GTR No. 9 Amendment

NHTSA test data analysis

NHTSA Understanding of Amendment 3

2010 Kia Forte – Side, Passenger Side

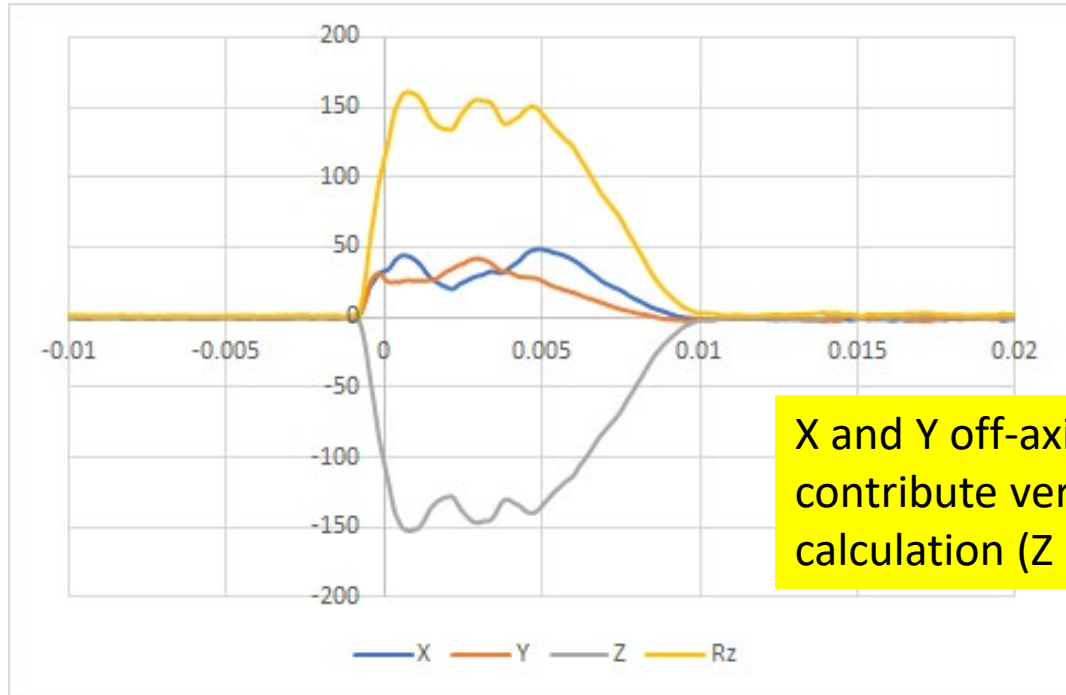
Point of First Contact Method
HIC15 = 1587

Aiming Point Method
HIC15 = 927

2010 Kia Forte – Side, Passenger Side

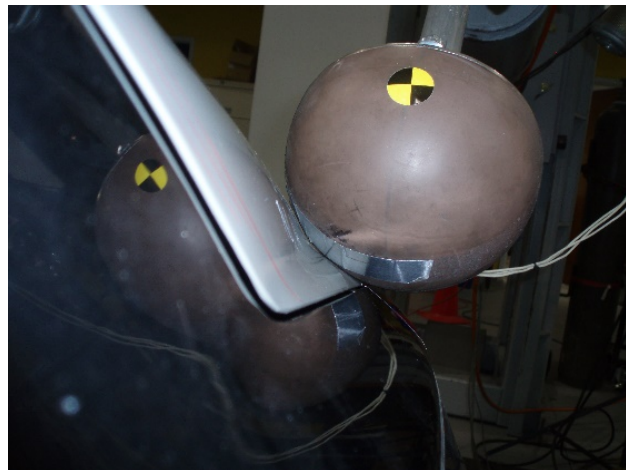
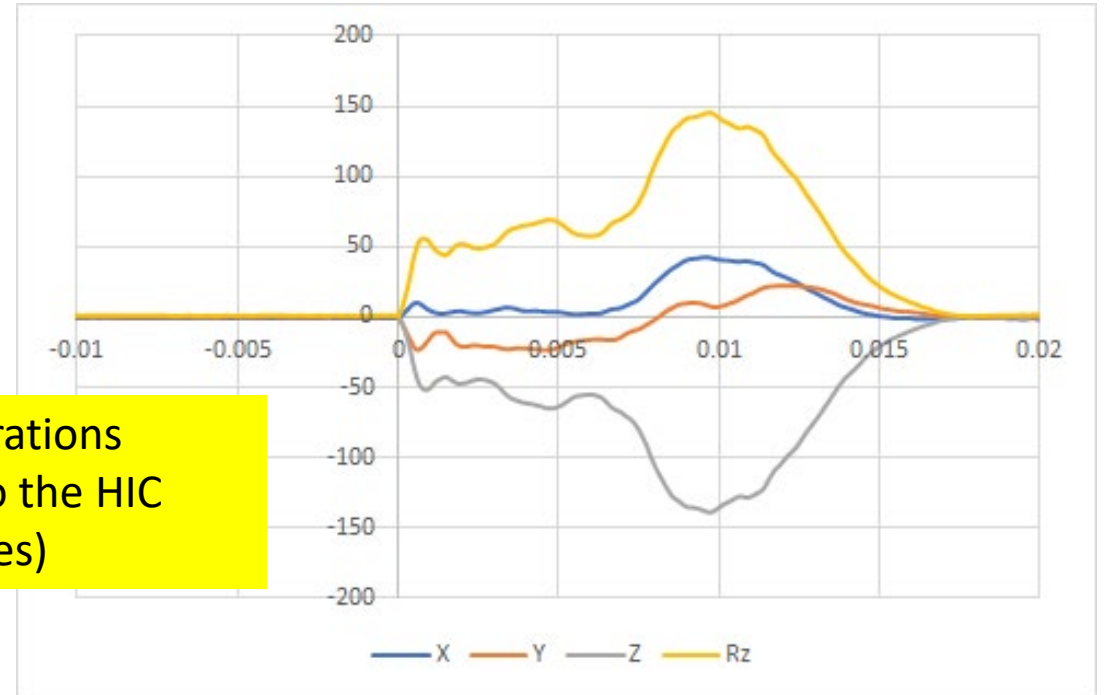
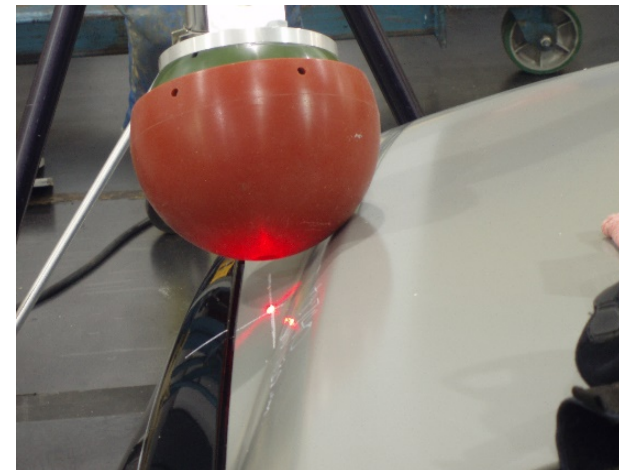
X and Y off-axis accelerations contribute very little to the HIC calculation (Z dominates)

2010 Kia Forte – Side, Passenger Side

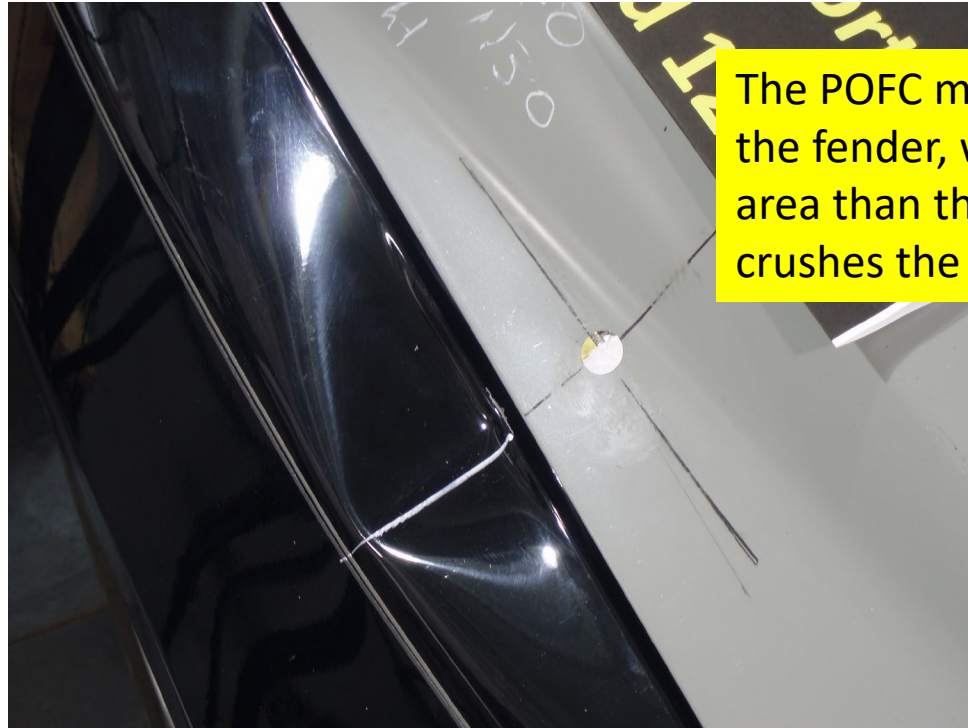
The POFC method encompasses the fender, which is a much harder area than the AP method, which crushes the hood primarily

2010 Buick LaCrosse – Side, Driver Side

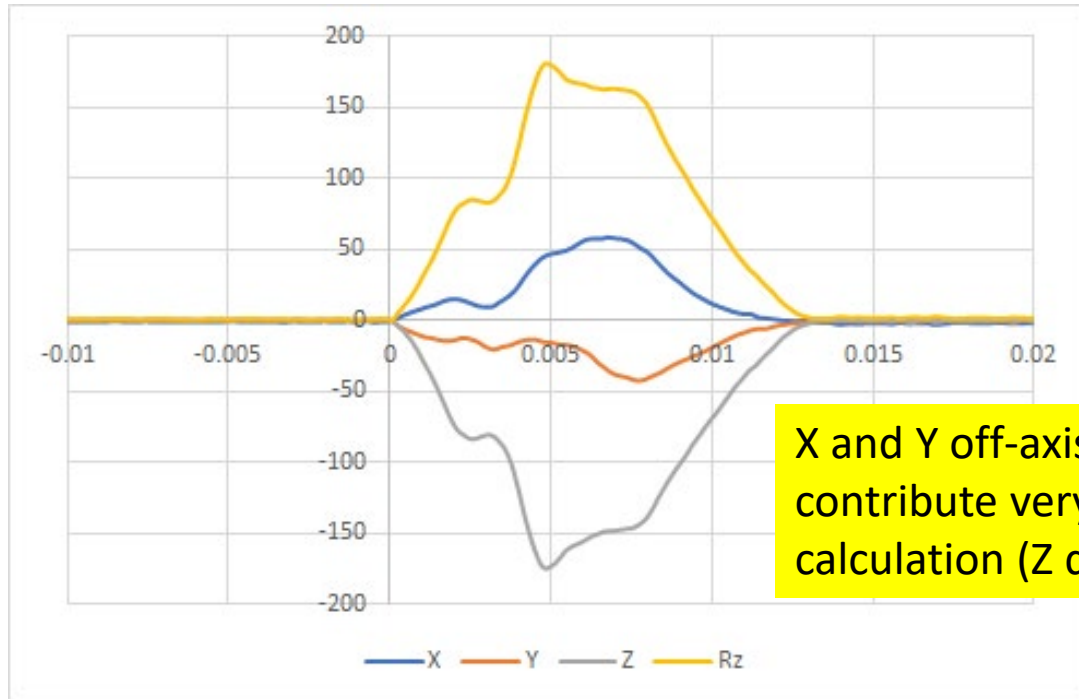
Point of First Contact Method
HIC15 = 1602

Aiming Point Method
HIC15 = 888

2010 Buick LaCrosse – Side, Driver Side

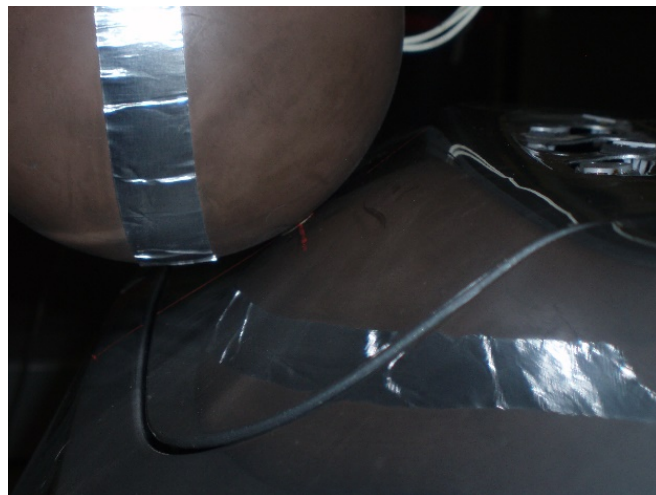
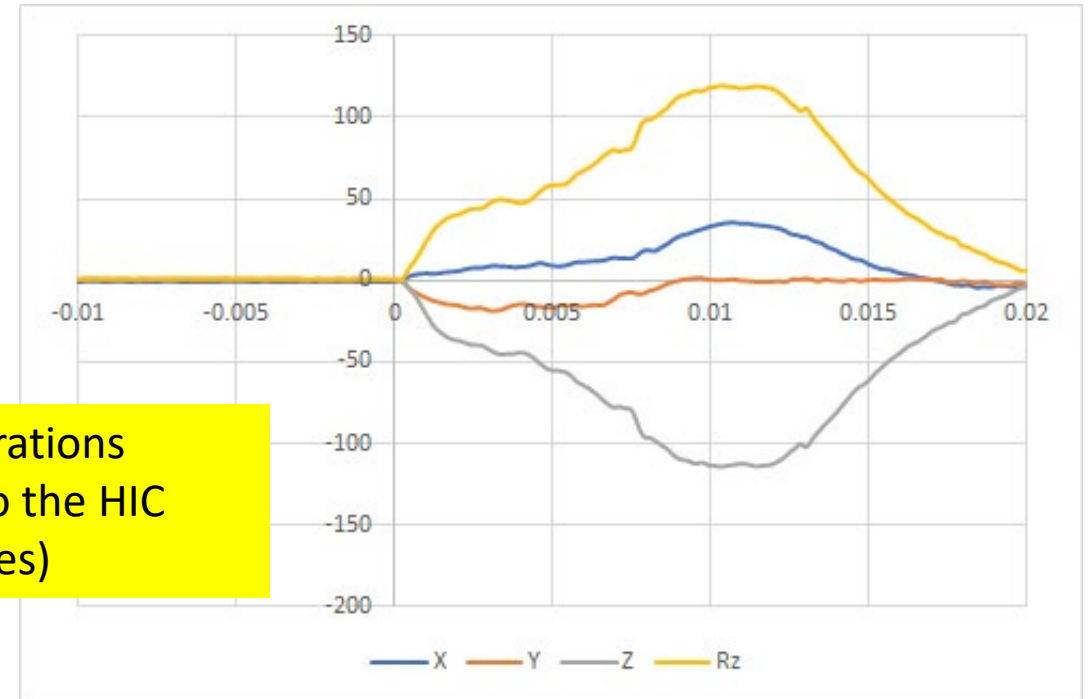
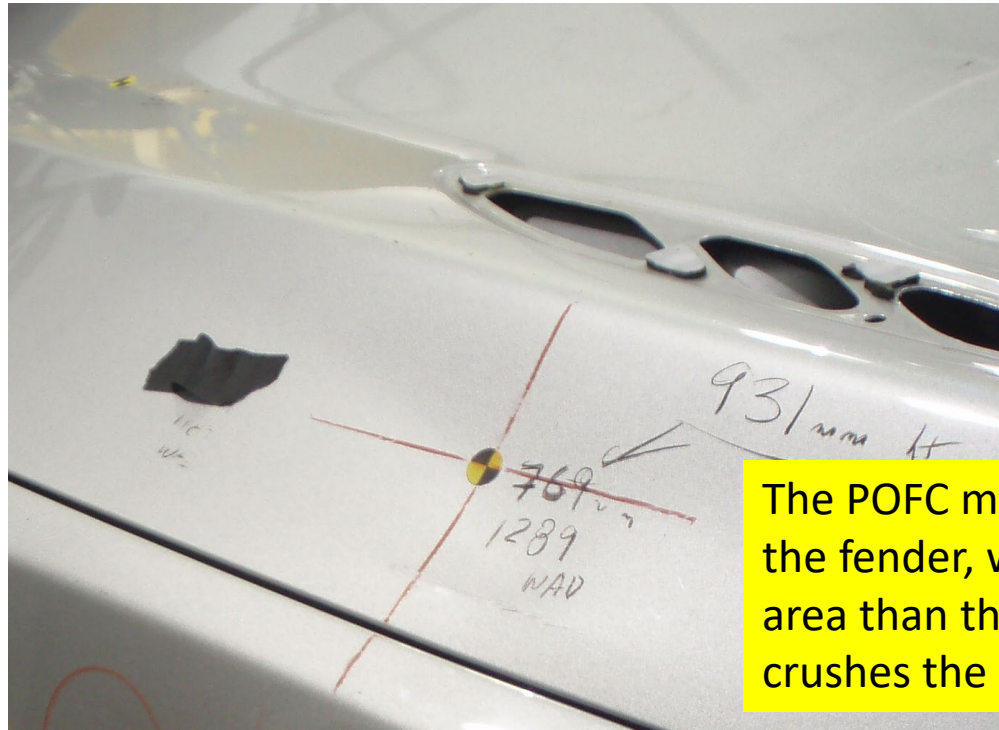
X and Y off-axis accelerations contribute very little to the HIC calculation (Z dominates)

2010 Buick LaCrosse – Side, Driver Side

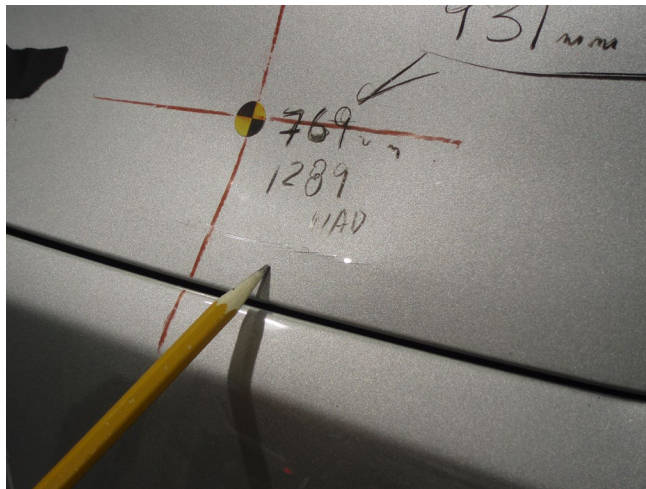
The POFC method encompasses the fender, which is a much harder area than the AP method, which crushes the hood primarily

2010 Acura MDX – Rear, Passenger/Driver Side

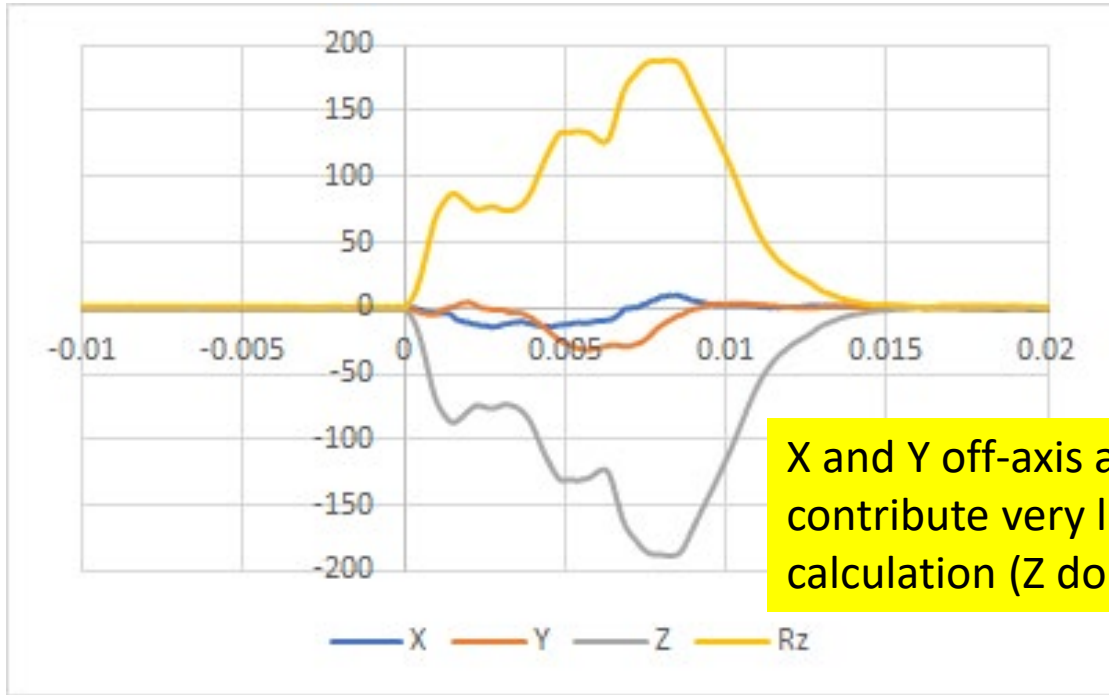
Point of First Contact Method
HIC15 = 1100

Aiming Point Method
HIC15 = 875

2010 Acura MDX – Rear, Passenger/Driver Side

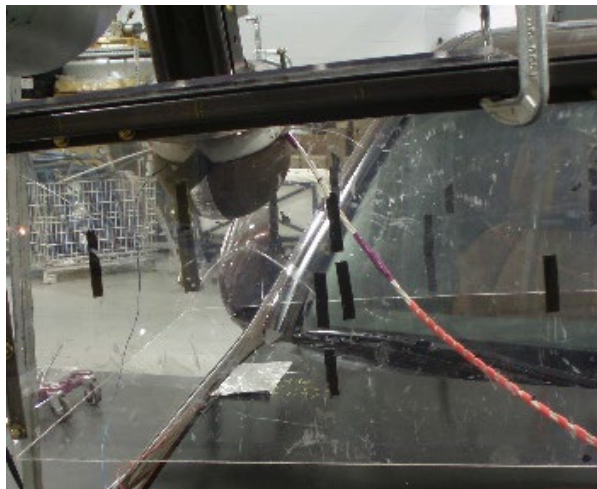
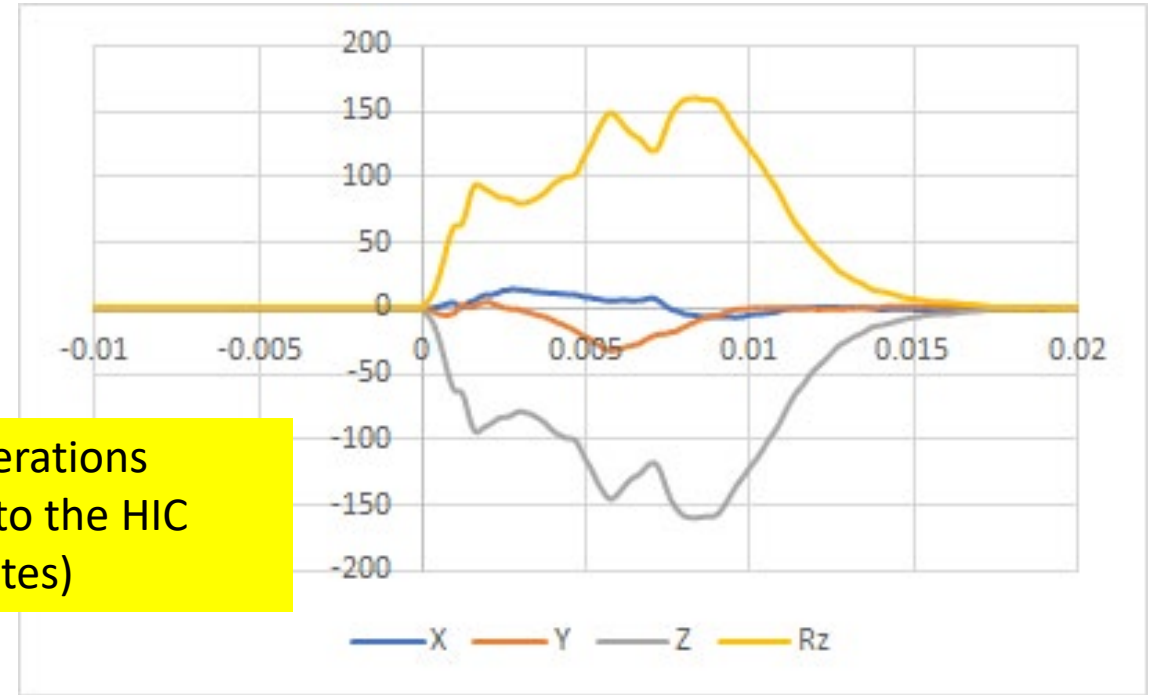
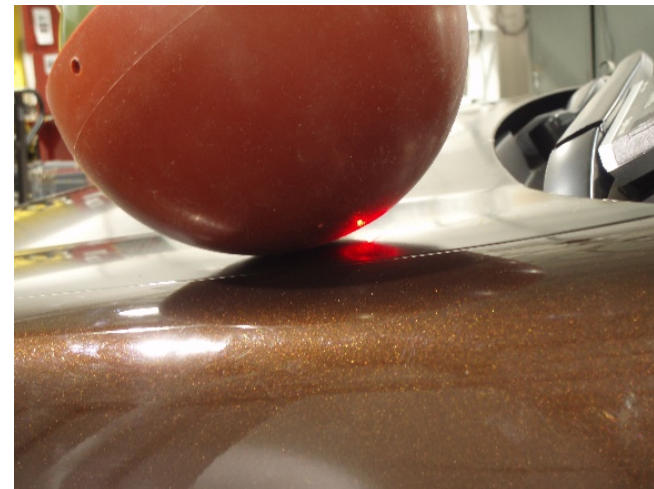
X and Y off-axis accelerations contribute very little to the HIC calculation (Z dominates)

2010 Acura MDX – Rear, Passenger/Driver Side

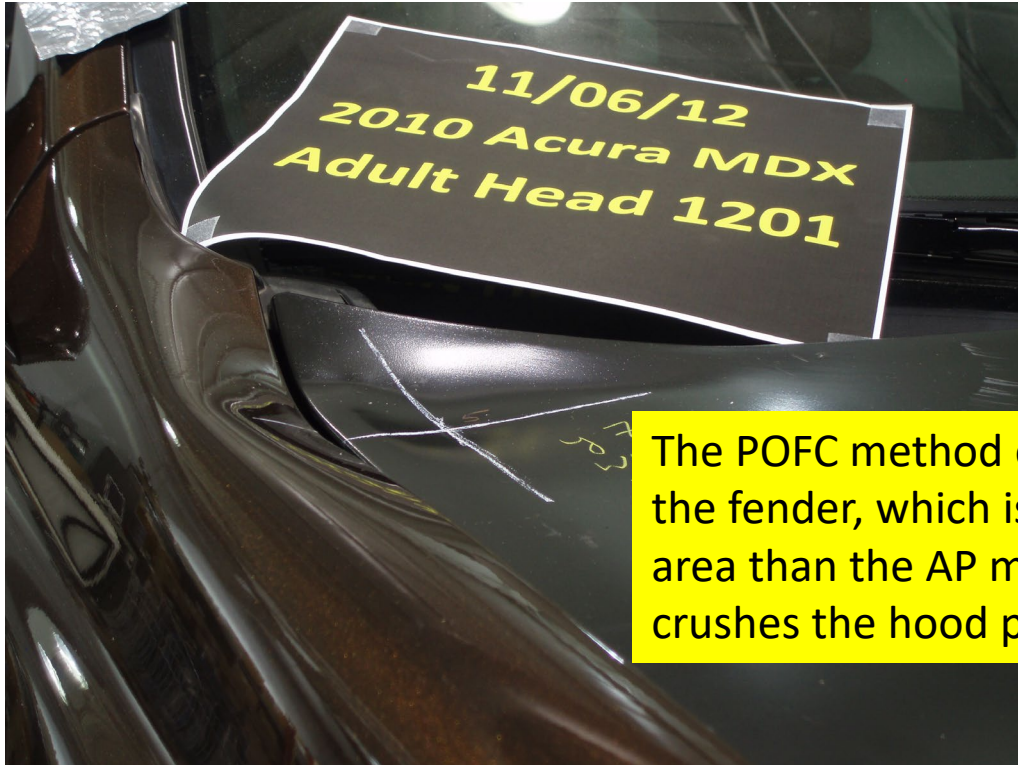
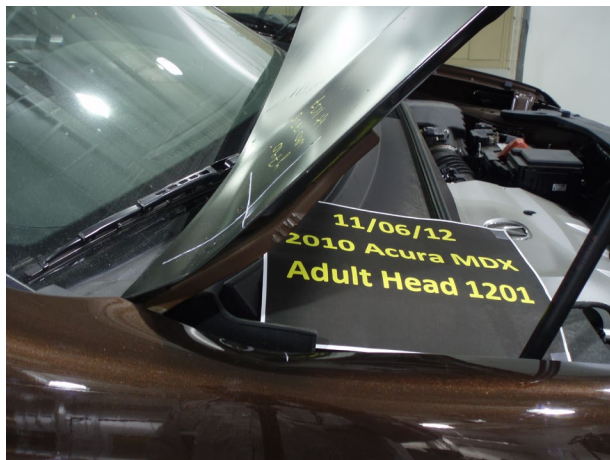
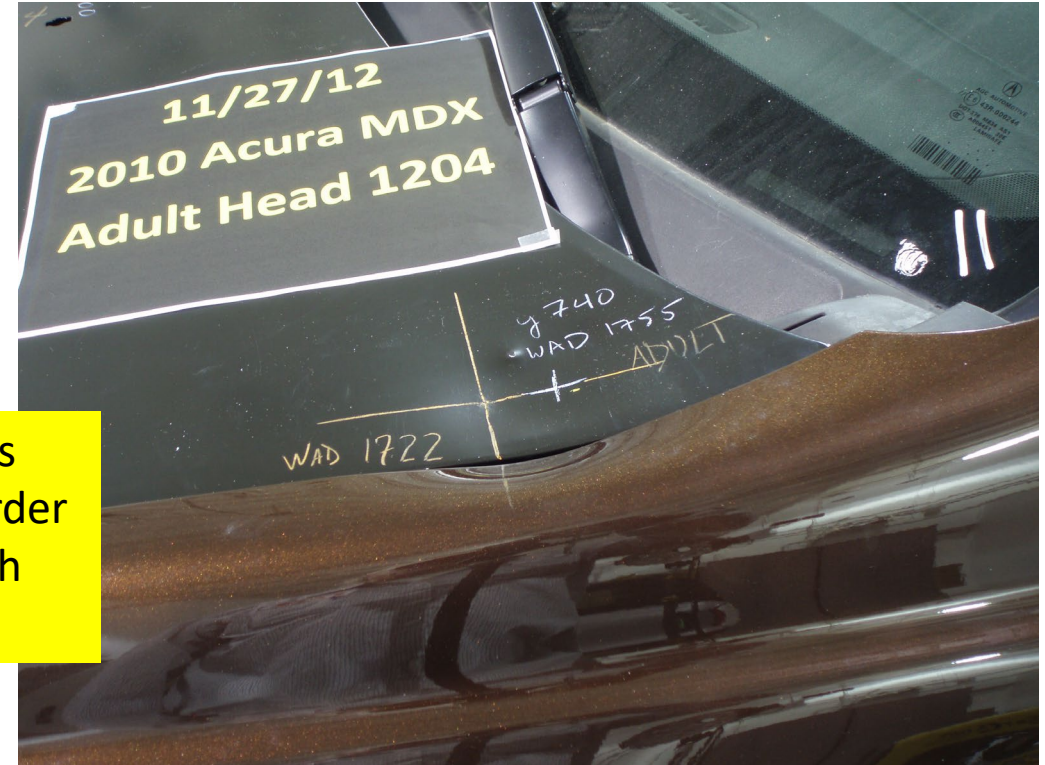
The POFC method encompasses the fender, which is a much harder area than the AP method, which crushes the hood primarily
